# Bathampton Rail-Based Park and Ride Options

Consideration of OTB Proposal

October 2015

Bath and North East Somerset Council

Figure 1.2: Potential Park and Ride Site H

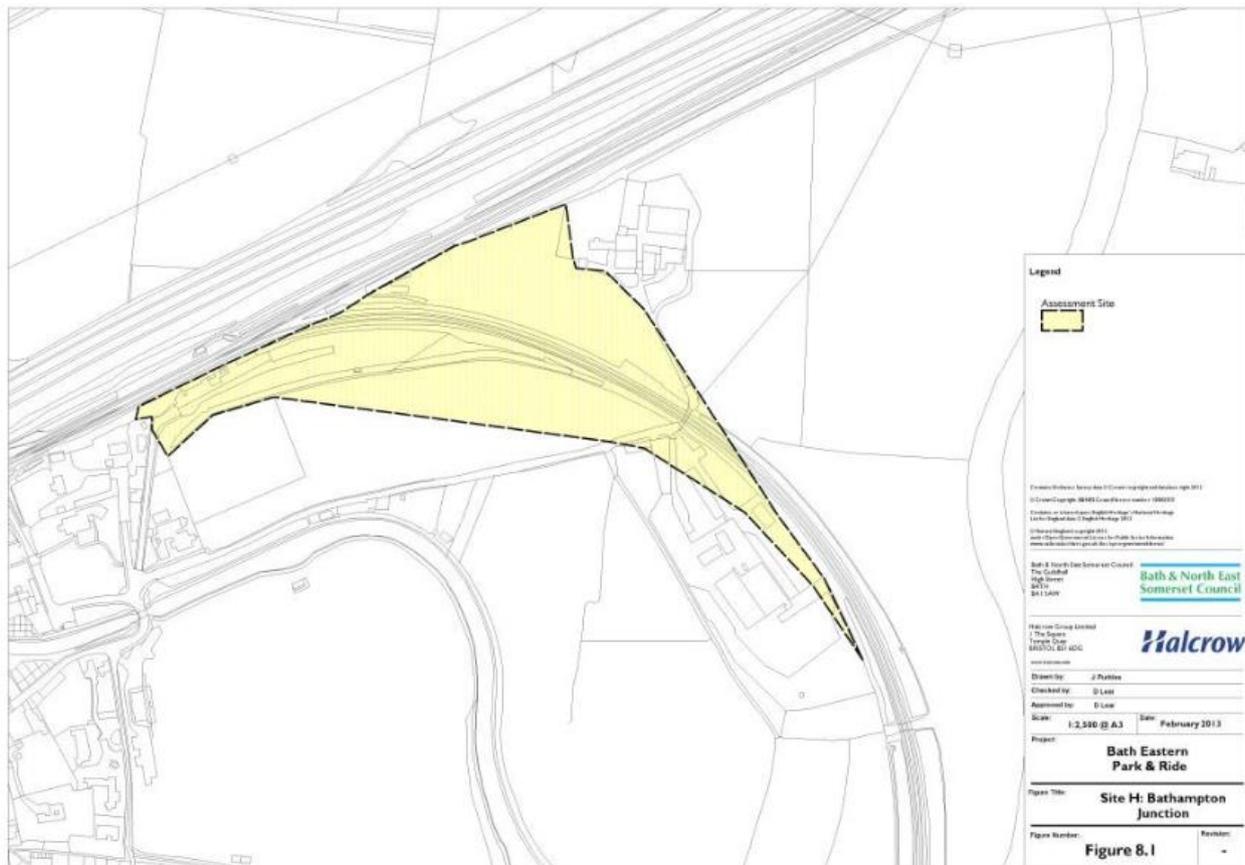
A review has been undertaken<sup>3</sup> of possible Park and Ride sites to the east of Bath which included 'Site H' – the OTB proposed site – as shown in Figures 1.1 and 1.2. This illustrates how the scheme requires the relocation of the railway. The review considered all the site options on a comparative basis and noted the following in its Summary Table 10.1:

- **Highway access** – 'Substantial and expensive bridge works needed to insert large structures under the [Great Western Main Line] and A4 Batheaston Bypass' and 'Access to Bathampton Farm is severed by the removal of the level crossing.'

- **Rail engineering** – 'Substantial track alterations to re-align the Westbury line and track switches at Bathampton Junction. Associated signalling works and the provision of a new station needed. Service reliant on the delivery of the Greater Bristol Metro and existing service using the Westbury line. Spare capacity on the latter services in the weekday peak periods is assumed; which is unlikely to be the case. Re-alignment of the Westbury line would require acquisition and demolition of a residential property on Tying Road (The Skillings).' [The adjacent builders' yard would also be affected.]

Figure 2.1: Proposed Location of Interchange Facility

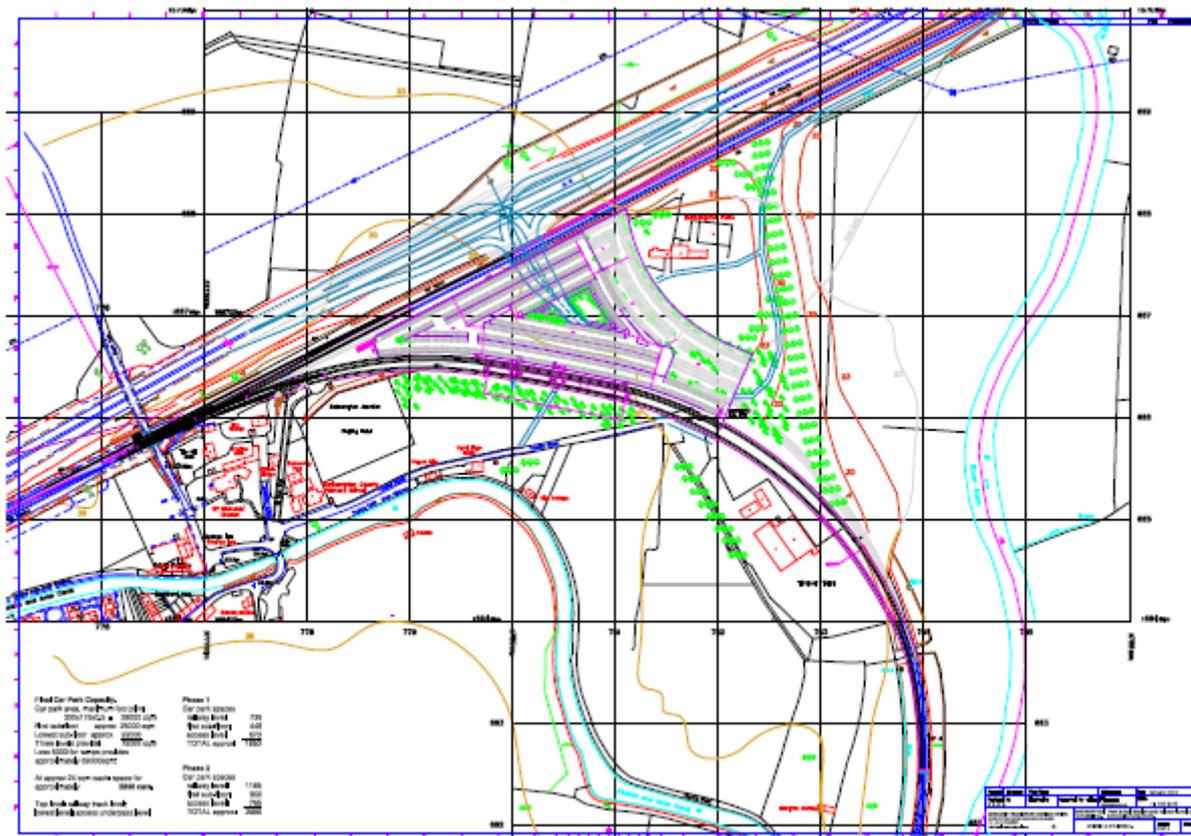
The location of the OTB proposal at Bathampton Junction suggests that rail services using the Trowbridge Line (Bath Spa to Westbury route) would serve the new facility. This would enable Park and Ride users to access a range of services to access Bath Spa, Oldfield Park and services beyond to Keynsham and Bristol. However, the Bathampton facility has been shown to require major reconstruction of the rail alignment in the area including the relocation of Bathampton Junction where the Trowbridge line diverges and the realignment of the curve on the Trowbridge Line (see Figure 2.1). This would necessitate moving Bathampton Junction to the west and hence reconstruction of Mill Lane bridge which has not formed part of the recent main line electrification works. The OTB proposal aims to accord with Network Rail's GRIP (Guide to Railway Investment Project) process Stages 1 and 2 in identifying the scope and indicative business case for a scheme but fails to take into account the prospects for deliverability at this location; it relies on space being freed up by the relocation of the junction. While the concept may not rely on relocating the junction, it does require a suitable space to construct a car park (on the site of the Bathampton Farm buildings if the junction remains in its present location) and the challenge remains of providing station platforms to Network Rail's requirements.

Realigning the Trowbridge Line curve to create a length of straight track against which platforms could be constructed would require the shifting of Bathampton Junction 200m to the west. The electrification works for the GWML upgrade have not included this. In addition, there are two major constraints affecting the location of the junction:

- **Mill Lane Bridge** is a listed structure of historic importance. The GWML upgrade has retained this structure but lowered the track to allow space for the overhead power lines. To move the junction, the

bridge would need to be reconstructed to overcome the constraints presented by its supporting structure; and

- An **electrical transformer** required for the electrified main line is to be located adjacent to Bathampton Junction. This is a substantial structure for which a number of locations were considered by Network Rail. The decision to locate it at Bathampton Junction reflected Network Rail's requirement to locate it in the most suitable place to meet current and future needs.

Figure 2.2: Indicative Access From A4 (Single Bridge Beneath Great Western Main Line)

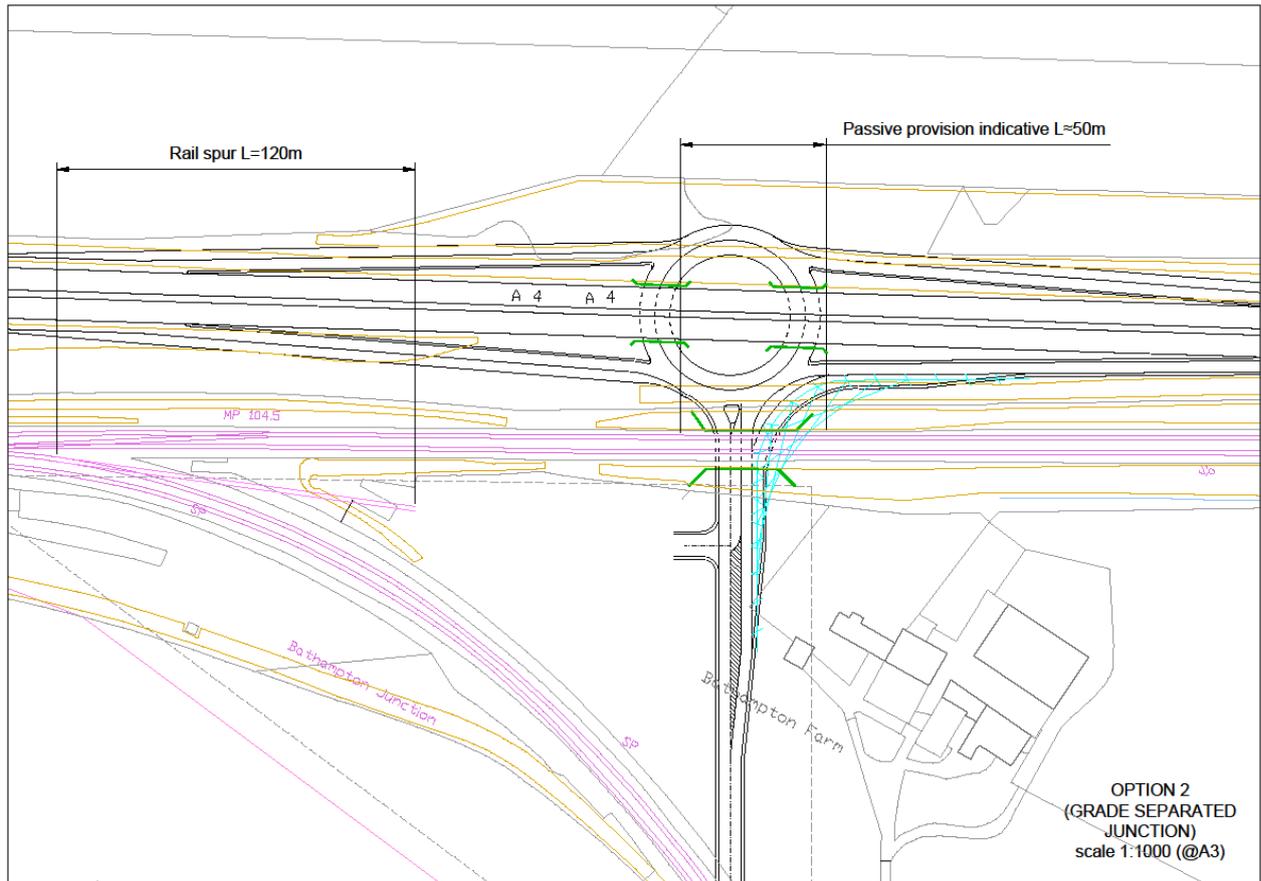
need to include a road link from the site to the A4 Bathampton Bypass is also challenging because it would require at least one substantial structure to be provided beneath the GWML. The alignment of the A4 dual carriageway and the vertical profile of the road in relation to the railway embankment indicate that designing and delivering slip roads would present significant challenges, particularly if the access were to be designed to Highways Agency standards should a new A4 to A36 link on this alignment be constructed subsequently. While accesses could be constructed, they will need to take into account the location of railway structures and would involve construction of new bridges for insertion beneath the railway. As the OTB proposals notes, adequate vertical clearance would be required for double deck buses to serve a Park and Ride site in the first instance (or for rail replacement services if required) and standard clearance for a public highway in addition to constructing gradients in accordance with Highways England specifications, especially if this access were to eventually become part of the road network. Mott MacDonald has considered the highway access options and indicated that substantial engineering work would be required (see Figures 2.2 and 2.3 as examples) . New slip roads to the A4 may also require a shift in the alignment of the dual carriageway. The proposal envisages a multi-storey car park structure, the top of which would be at the level of the main line railway embankment which requires some excavation to achieve.
